Application Reference:- M/123/17/HH

Two storey extension to existing building.

Little Thatch, 93 Middleton Road, Middleton on Sea PO22 6DW

The 'set back' of no. 93 makes its neighbours much more sensitive to additions.

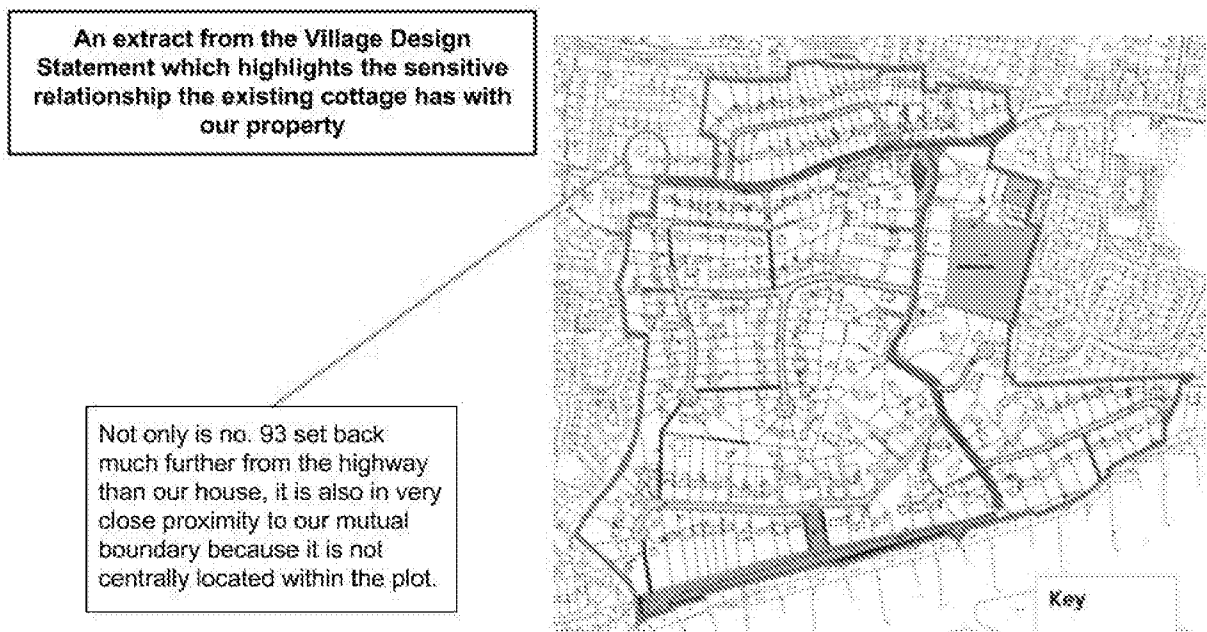
The dwelling at no. 93 is set back from the public highway much more than the others nearby on the northern side of Middleton Road. This alignment is of particular relevance because it results in any developments having a greater impact on the most sensitive area of adjacent gardens than would otherwise be the case - and especially ours. As a Location or a Block Plan has not been submitted this relationship is not apparent to those who are being consulted (including the Parish Council). An extract from the Village Design Statement (VDS) is included below to show the position of our house in relation to no. 93.

The impact on our property

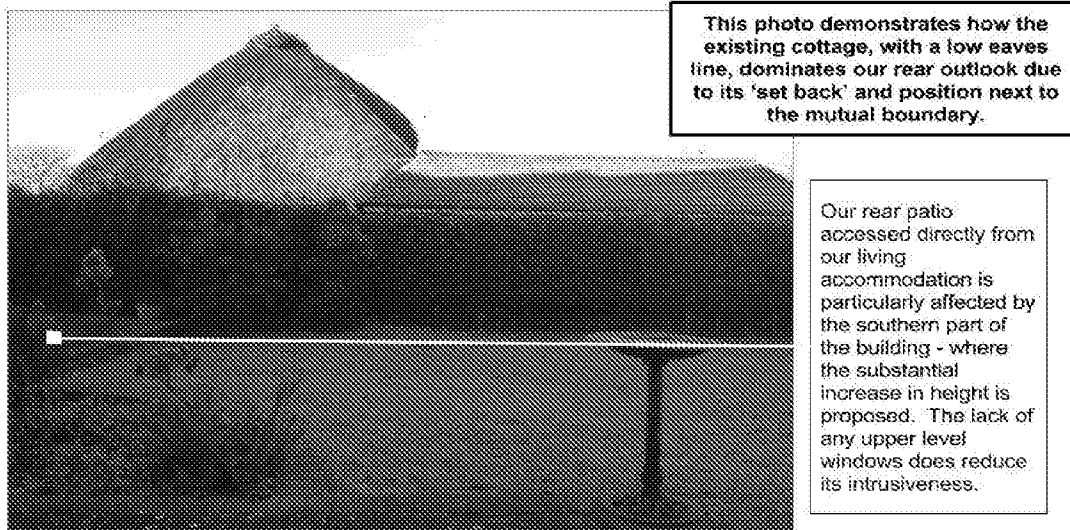
Focusing on the elevation facing our property, the configuration of the roof would look bulky and particularly awkward. The substantial increase in the height of the side elevation, as well as the eaves and ridgeline of the roof itself, would be particularly dominating. The two-storey house that would be created would have an over-bearing presence on us, resulting in a loss of outlook and light levels, particularly at the rear of property, especially in the afternoon during the months when the sun is lower in the sky.

Currently there are only ground floor windows facing us at no. 93, hidden behind the fence (which is not acknowledged in Section 15 of the Application Form). The proposal includes three more windows above on the upper levels. The two rooflights would serve Bedroom 4 and the stairway area leading to it. Neither of these appear to be necessary and we consider them to be un-neighbourly. The window serving the un-named room (which could be a walk-in wardrobe or study area etc) is also un-neighbourly and adds to the presence of being continually overlooked. We are also concerned that an alternative internal layout (which wouldn't be subject to Planning permission) could exacerbate the loss of privacy in the future.
